**TOWN OF BROOKLYN
PLANNING AND ZONING COMMISSION
Special Meeting Agenda
Wednesday, July 8, 2020
6:30 p.m.**

ENGINEERING PLAN REVIEW

The comments contained herein pertain to my review of plans, consisting of six sheets, entitled "6-Lot Subdivision, Prepared for Jeffrey Weaver, Day Street, Brooklyn, Connecticut" prepared by Archer Surveying, LLC and Provost & Rovero, Inc., dated February 7, 2020.

Site Development Plan "6 Lot Subdivision"

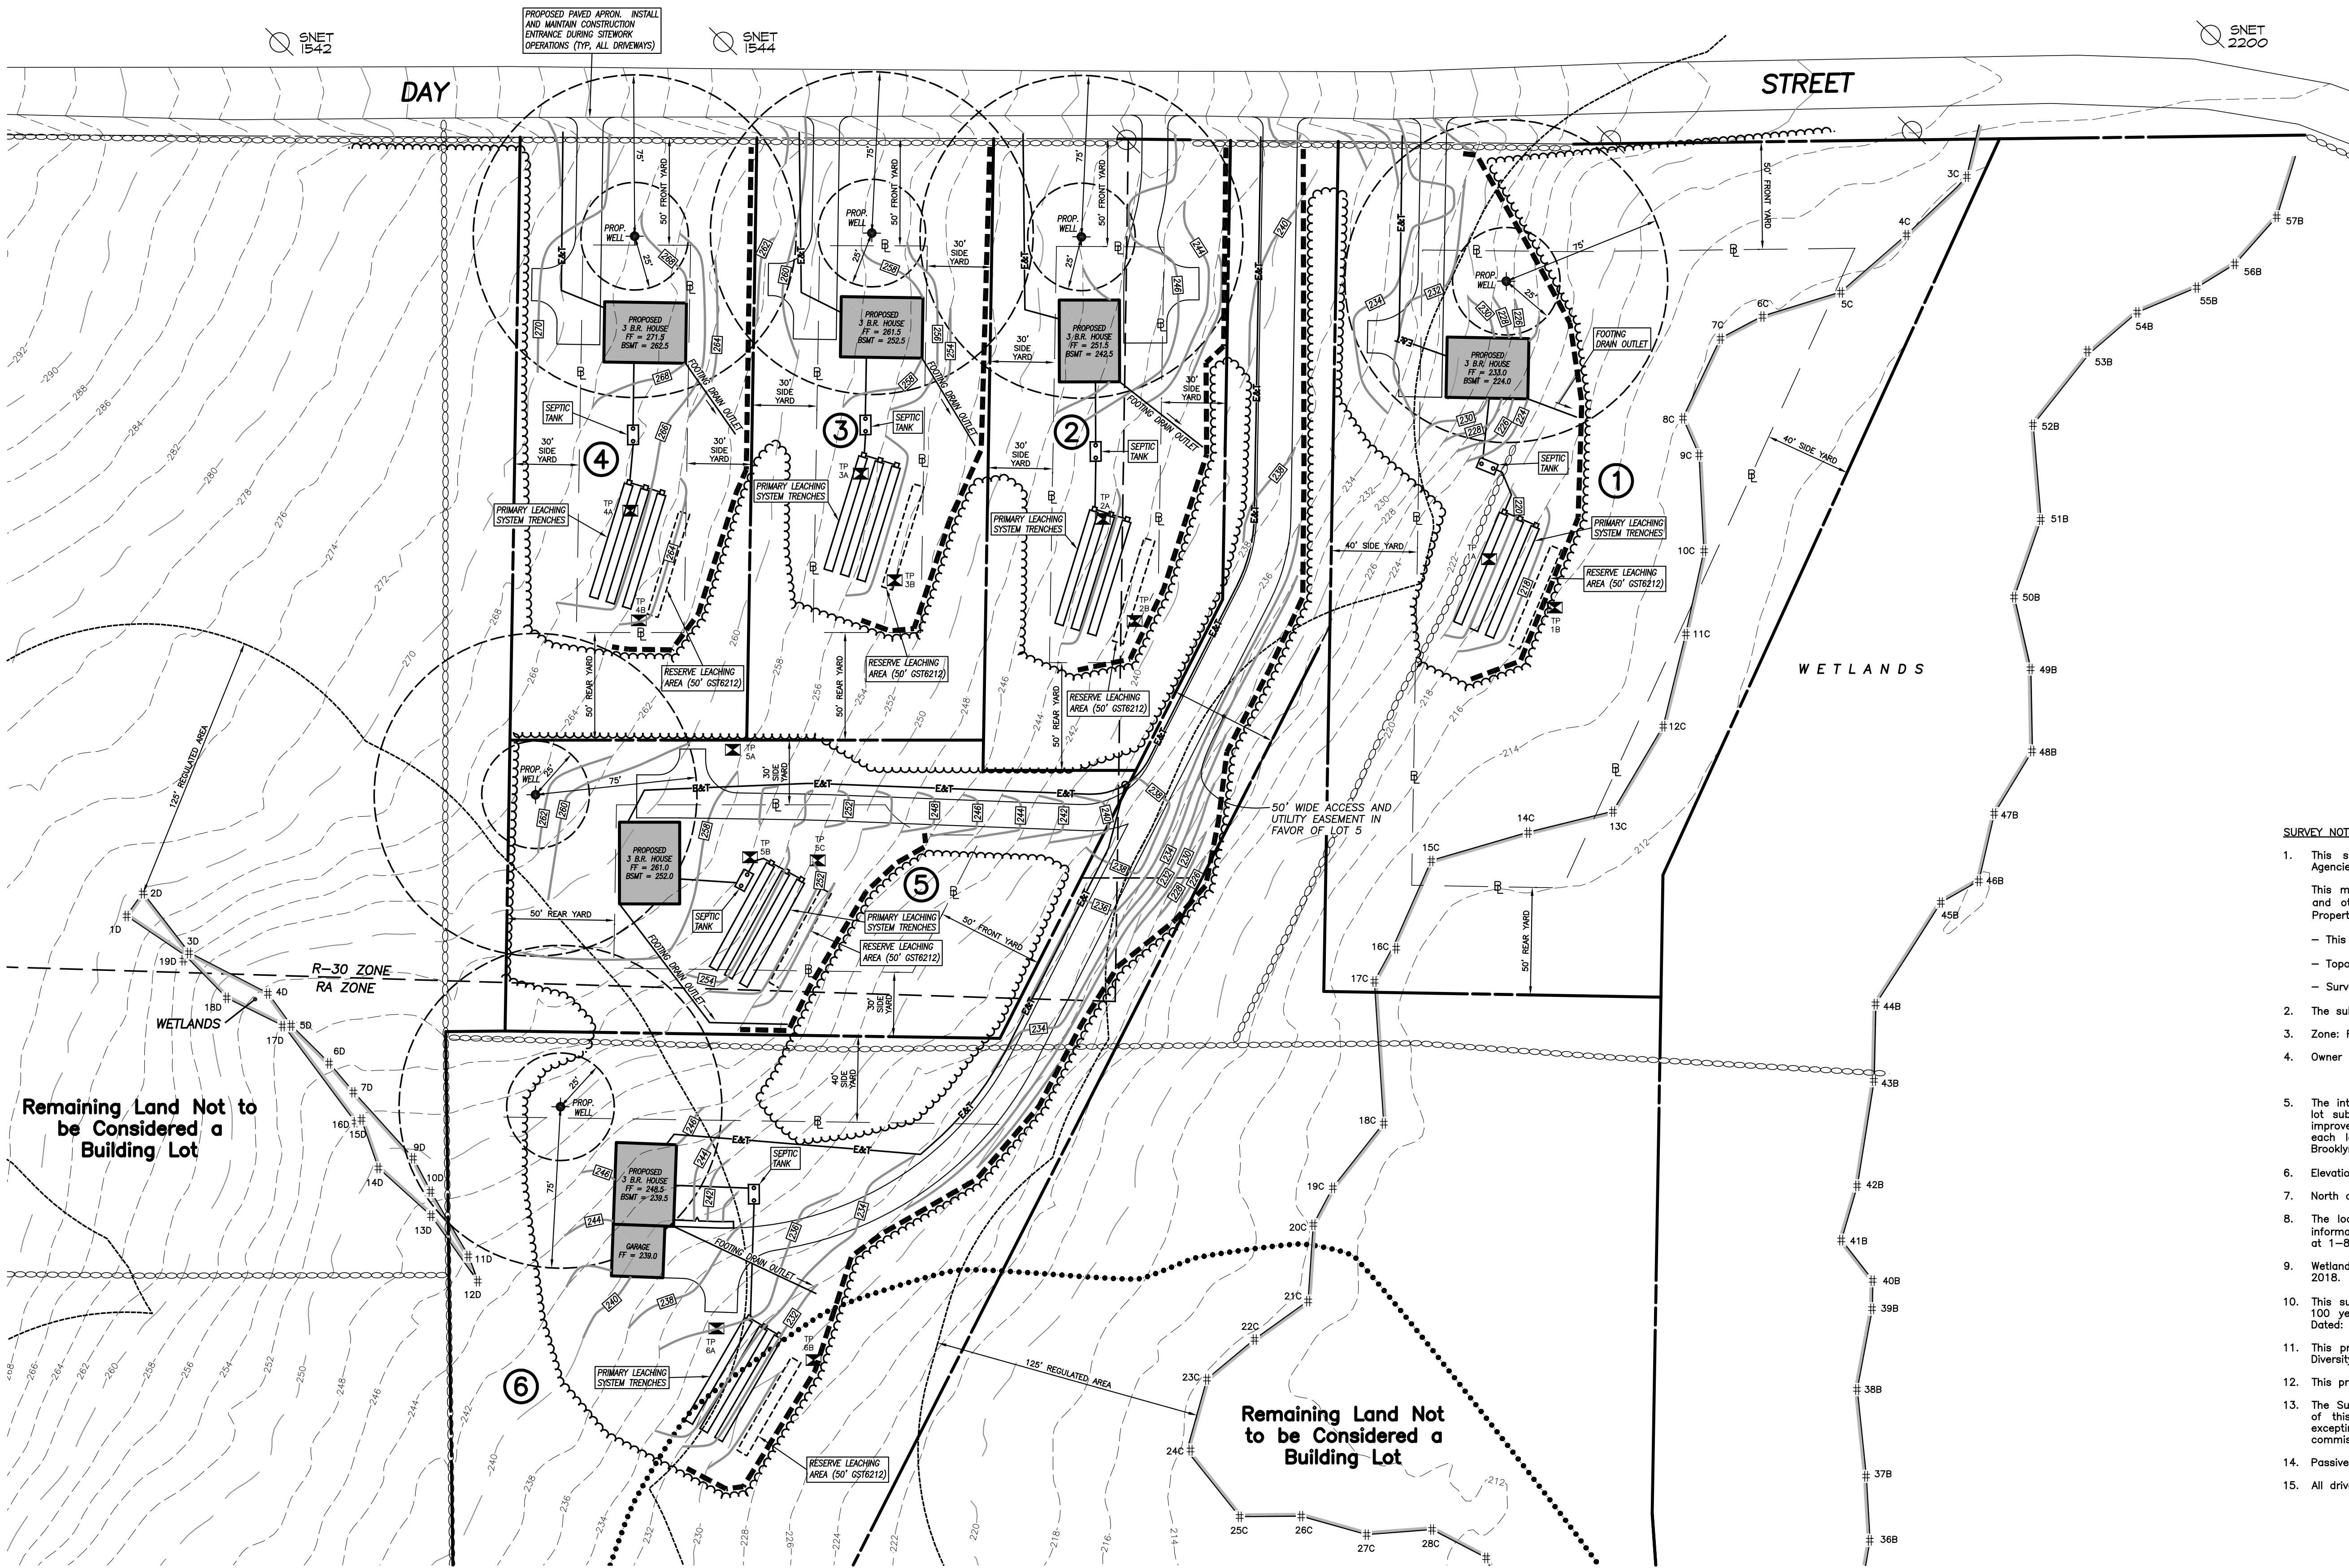
Sheet 3 of 6 – Site Development Plan

2. The vast majority of the Lot 1 is in the regulated wetland upland review area as well as about half of Lot 6. This may be of concern and should be taken under consideration with respect to future improvements to the building lots after a house is constructed, e.g. additional pavement or impaired impervious areas that could contribute detrimental runoff toward the wetland without any regulatory oversight by the Inland Wetlands and Watercourses Commission or the Planning and Zoning Commission.

Detail Sheet No. 1
"6 Lot Subdivision"

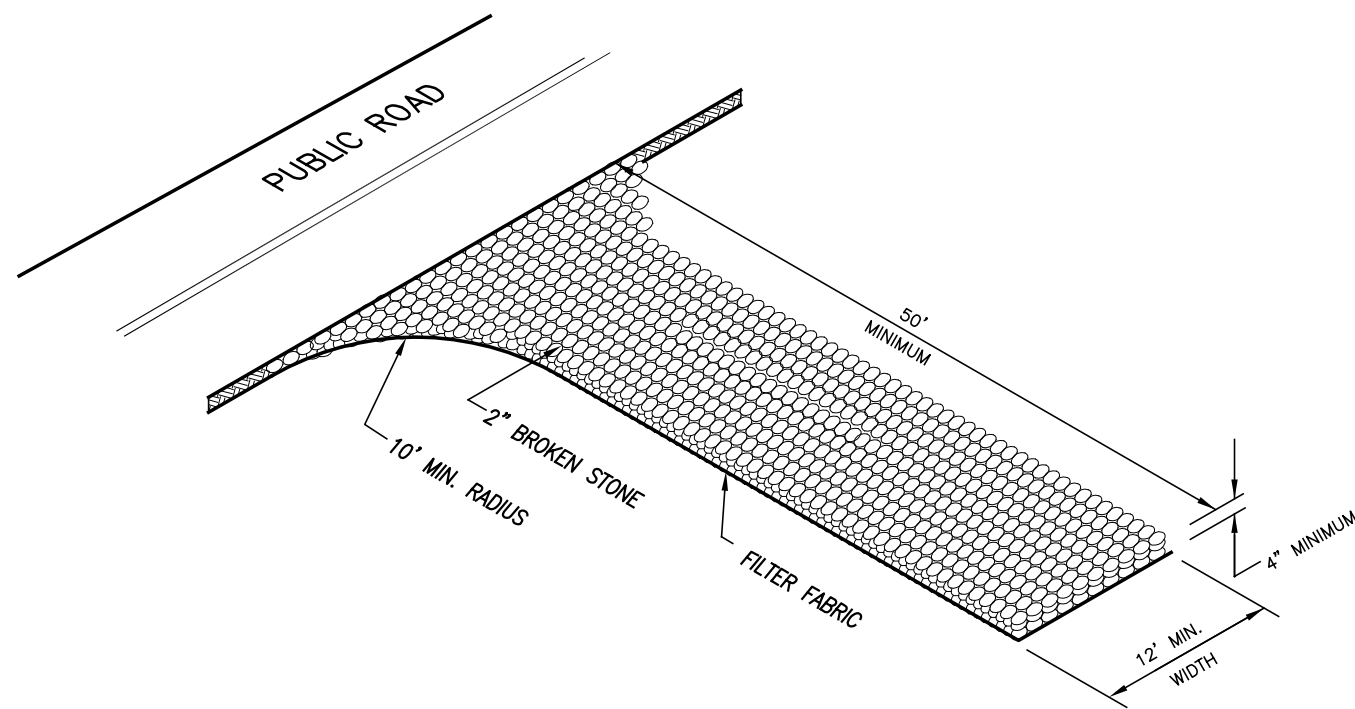
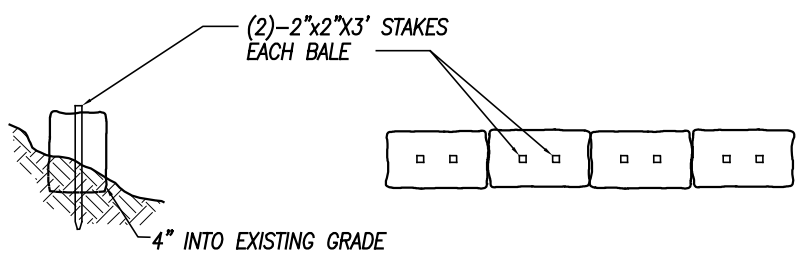
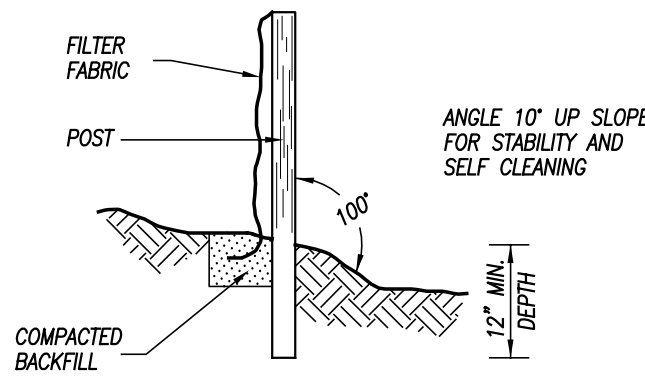
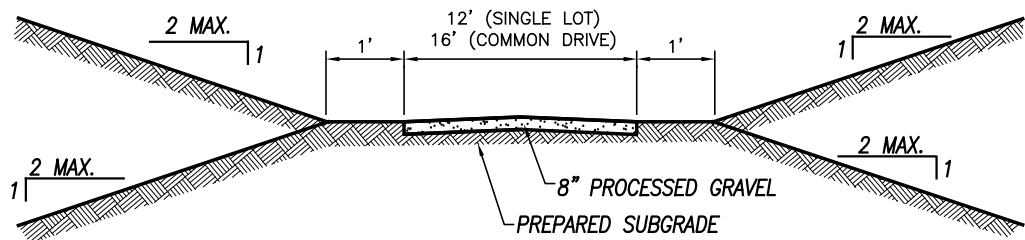
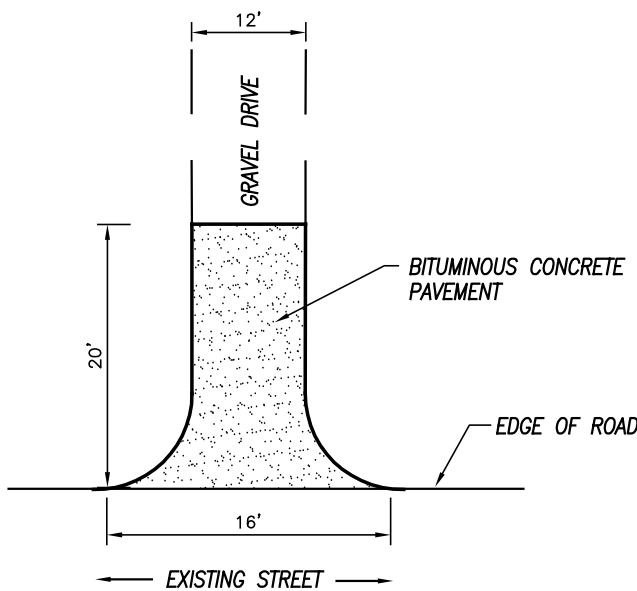
Sheet 4 of 6 – Detail Sheet No. 1

1. Proposed grading along the east side of the proposed driveway in the vicinity of Lot No. 5 is drawn at a 2:1 slope. I recommend that the slope be no less than 3:1 to better establish vegetative growth and reduce the chance of soil erosion, with a note to this effect be included under the heading "Development Control Plan."
2. Note 1 under "Development Control Plan" states that development of the site will be the responsibility of a lot owner. This being the case, I believe it is important that a permanent grass seed mix be spelled out under the heading "Permanent Vegetative Cover" to be sure that all of the development receives a uniform seed treatment.
